Statement of Response to LRD Opinion

Ref. Lrd2025004

**On lands located at
Kilwoghan Wood,
Crodaun,
Celbridge,
County Kildare**

Seattle Construction Limited

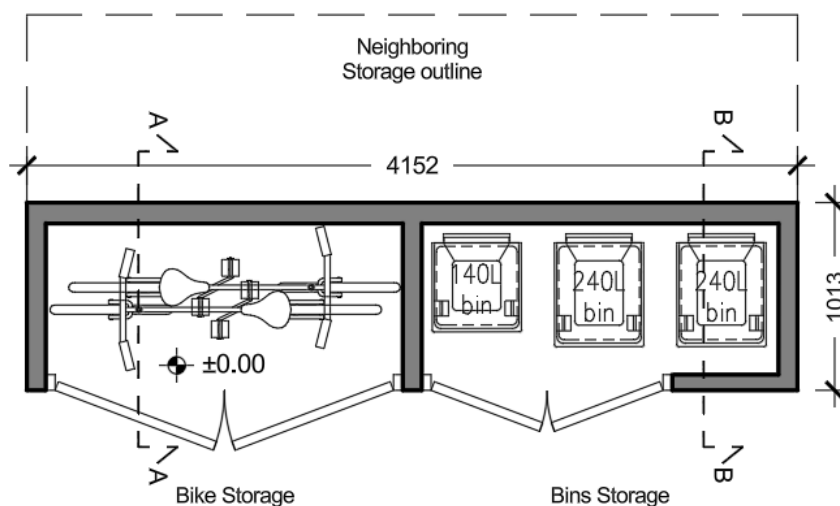
“Please clarify the location of all bin storage areas and note that they should be easily accessible to all apartment/duplex units and should be designed to correspond to the architectural design concept of the scheme- high quality finishes required.”

Below is the breakdown of the bin storage proposed across the whole of the new Phase 2 development. Please refer to drawing KWC-BB1-XXX-DR-JFA-AR-PP2401 for location of bins for houses and bike storage.
